# NEW MEXICO ABANDONED LAND MINE PROGRAM BOSTON HILL MINE SAFEGUARD PROJECT (PHASE I)

SILVER CITY, NEW MEXICO  
REVISED DECEMBER 2023

CO1 - WASTE ROCK AND BORROW AREA DETAILS

CO1-WASTEROCK AND MORTAR CLOSURE DETAILS

**BOSTON HILL SAFEGUARD FEATURES PLAN  
VIEW (2 OF 2)**

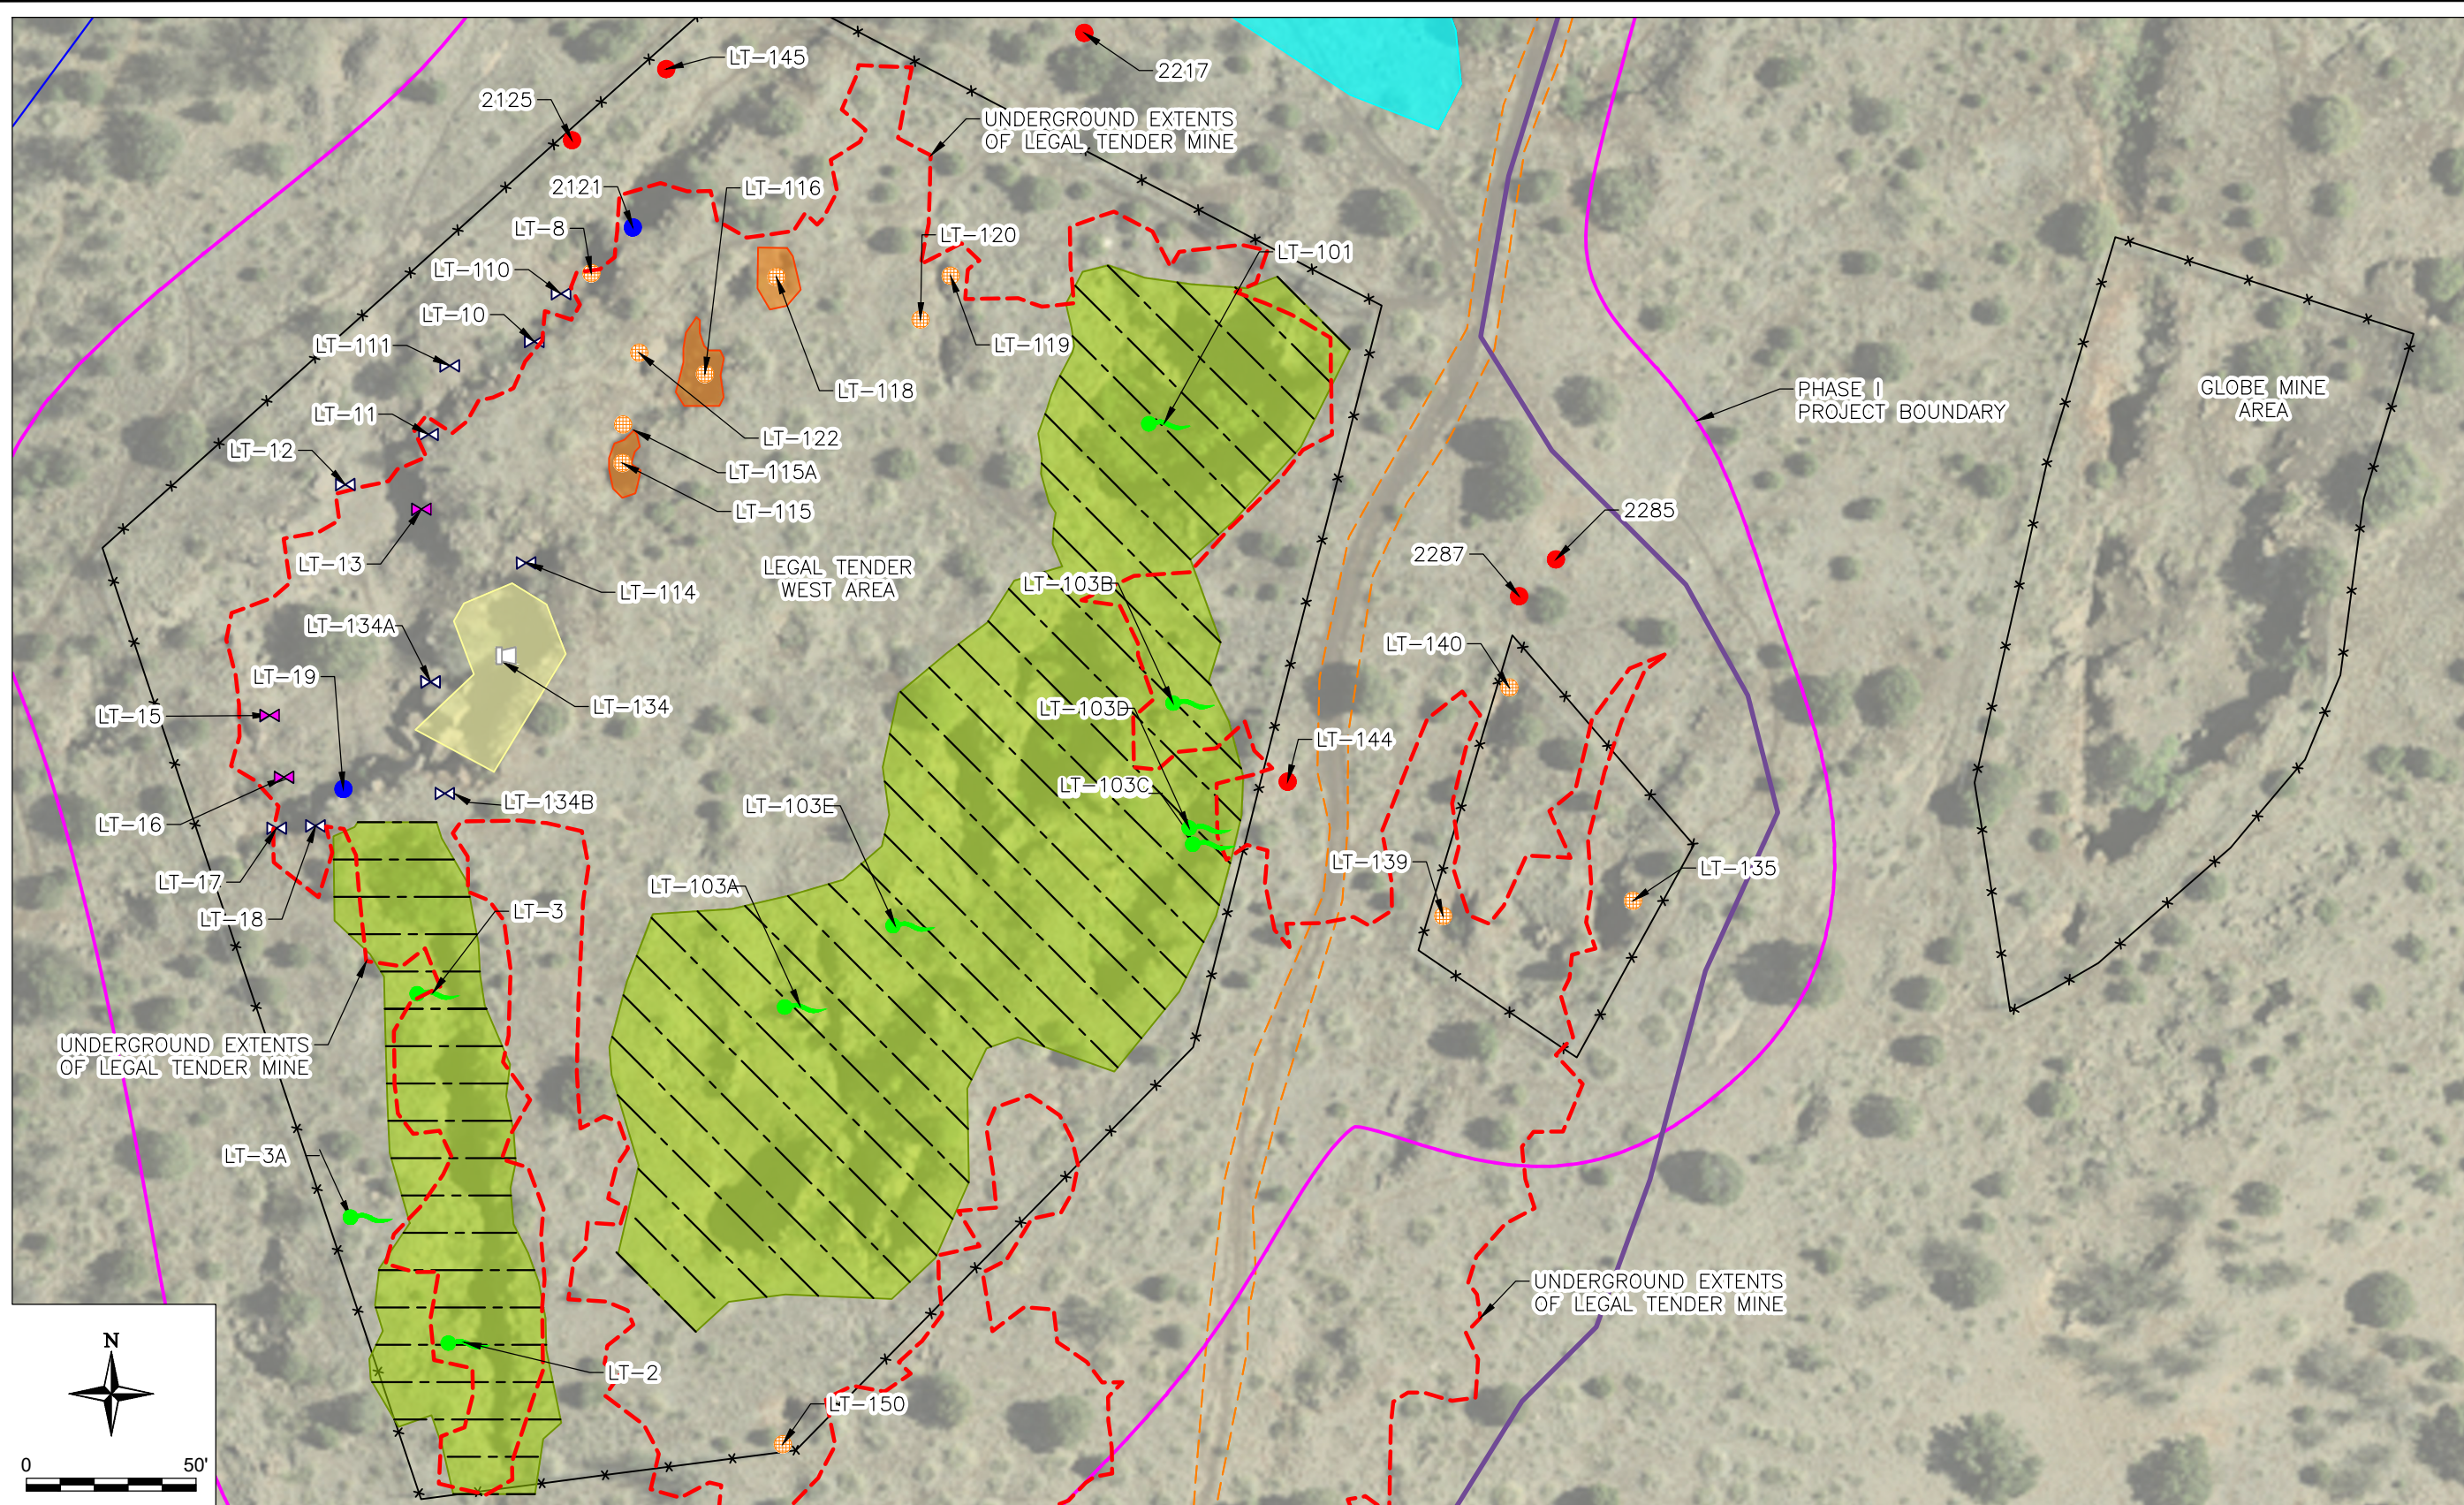
REV.	DATE	DESCRIPTION	BY	CHKD
1	11/03/2023	REVISED FEATURE CLOSURE TYPE (DMC)	DMC	MJM
0	01/19/2023	ISSUE FOR CONSTRUCTION	JD	TH
